Proposed Revisions to a Standard Plans Index

Originator:	Turley, Joshua	Index Number:	455-130
Date:	8/21/2024	Sheet Number(s):	2
E-mail:	Joshua.Turley@dot.state.fl.us	Index Title:	30" SQUARE CFRP & SS PRESTRESSED CONCRETE PILE

30" SQUARE CFRP & SS PRESTRESSED
CONCRETE PILE

INDEX
455-130

Sheet 2: Adjusted Strand Pattern diameter decimal places

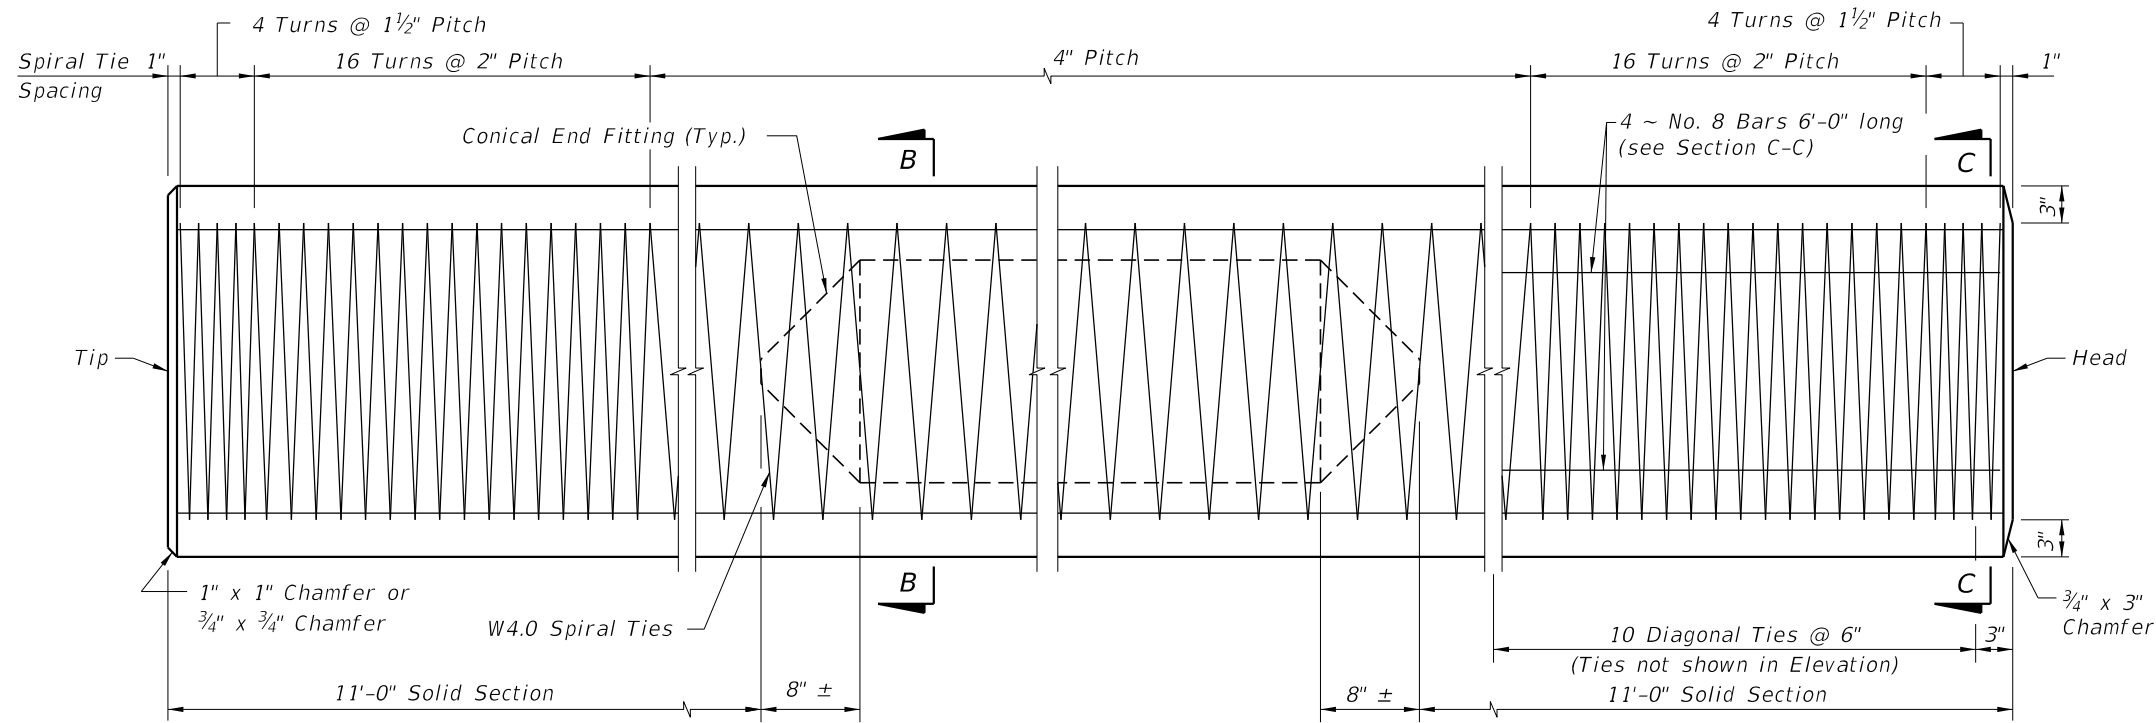
This is a more accurate representation of the nominal diameter driven by the fact that the strands are fabricated in millimeters not inches.

STRAND PATTERN

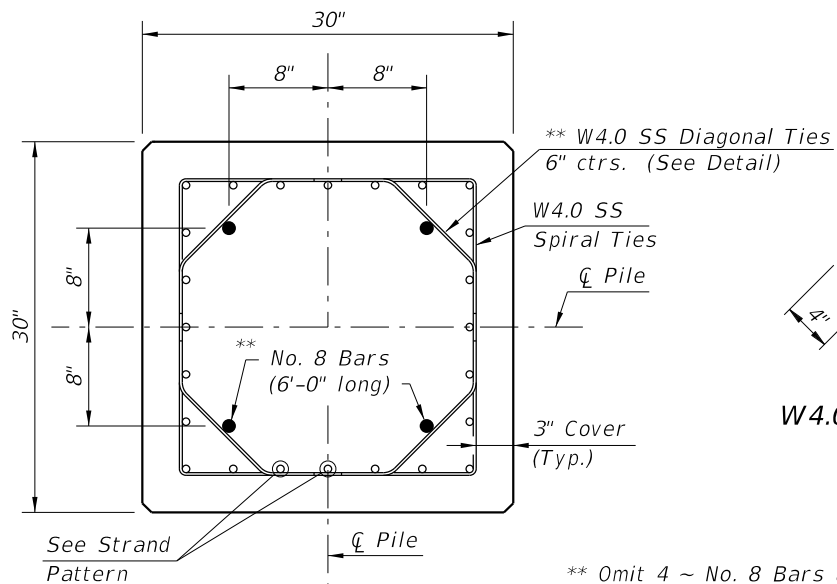
CHANGED TO: 0.520"

- 32 1/2" Ø, HSSS at 26 kips
- 24 0.6" Ø, HSSS at 35 kips

CHANGED TO: 0.620"

- 32 ~ 0.52" Ø, HSSS at 26 kips
- 24 ~ 0.62" Ø, HSSS at 35 kips
